## V2500-A1/A5/D5 SERIES PROPULSION SYSTEMS SERVICE BULLETIN

This document transmits Revision 2 to Service Bulletin EV2500-72-0470 and Revision 2 to the Supplement

# V2500-ENG-72-0470

ENGINE - HP COMPRESSOR DISCS (STAGES 3-8) - INTRODUCTION OF REVISED DISC ASSEMBLY  
WITH REDUCED STAGE 7 REAR DAMPER WIRE RETAINING WALL DIAMETER

A1 Engines Only - HP Compressor Stage 3-8 Disc Assembly Family Tree  
Sheet 1 of 3

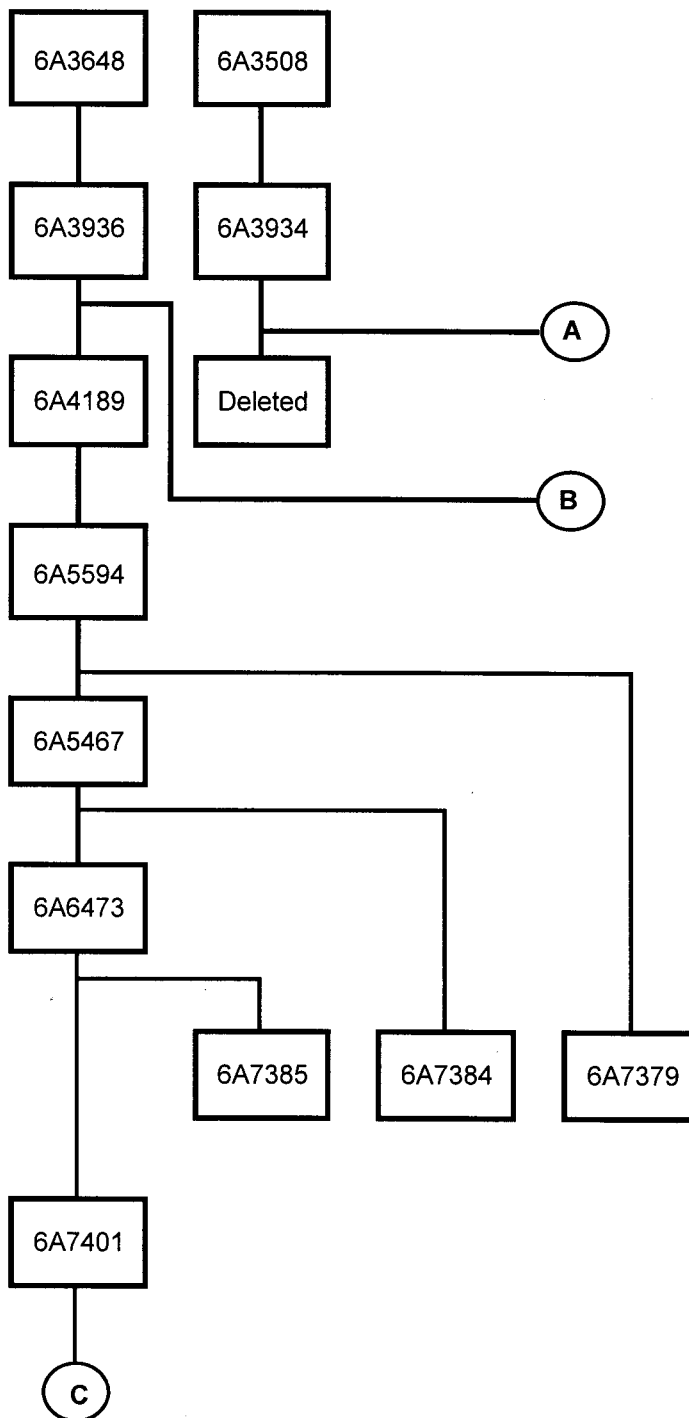
| Remove                            | Incorporate                           | Reason for change            |
|-----------------------------------|---------------------------------------|------------------------------|
| All pages of the Summary          | Page 1 and 2 of the Summary           | To revise Family Tree titles |
| All pages of the Service Bulletin | Pages 1 to 11 of the Service Bulletin | To revise Family Tree titles |

A5 and D5 Engines (not including A533) – HP Compressor Stage 3–8 Disc Assembly  
Family Tree  
Sheet 1 of 1

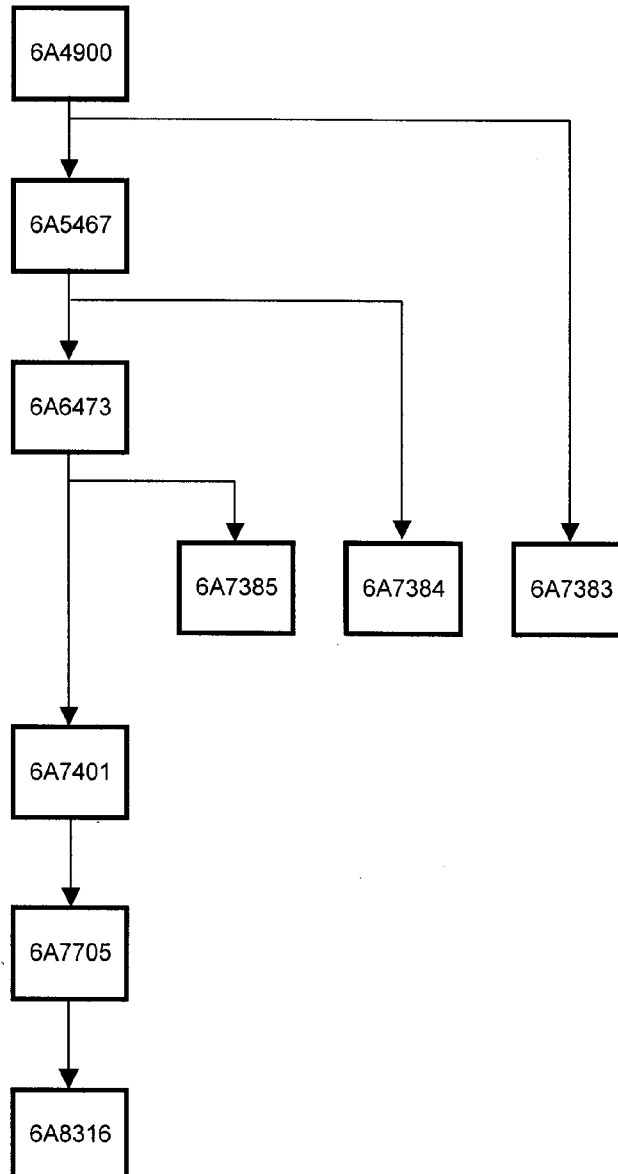
**V2500-ENG-72-0470**

Engine - HP Compressor Discs (Stages 3-8) - Introduction of a Revised Disc Assembly With Reduced Stage 7 Rear Damper Wire Retaining Wall Diameter

A533 Only - HP Compressor Stage 3-8 Disc Assembly Family Tree  
Sheet 1 of 1

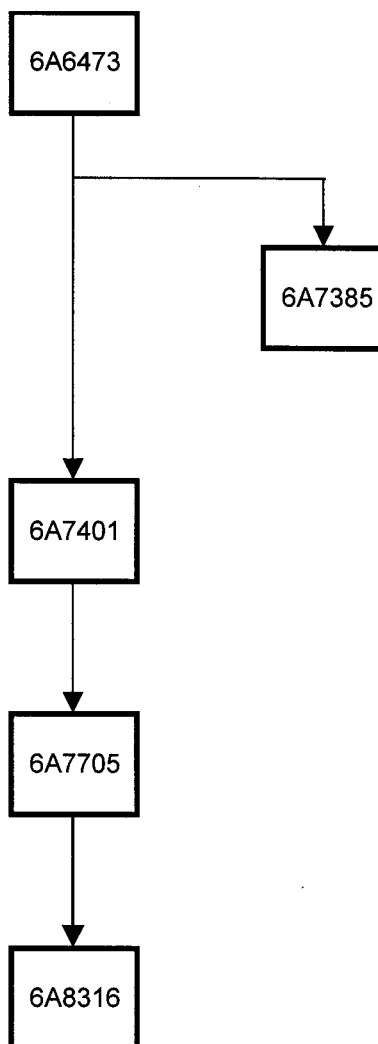
**V2500-ENG-72-0470**

Engine - HP Compressor Discs (Stages 3-8) - Introduction of a Revised Disc Assembly With Reduced Stage 7 Rear Damper Wire Retaining Wall Diameter
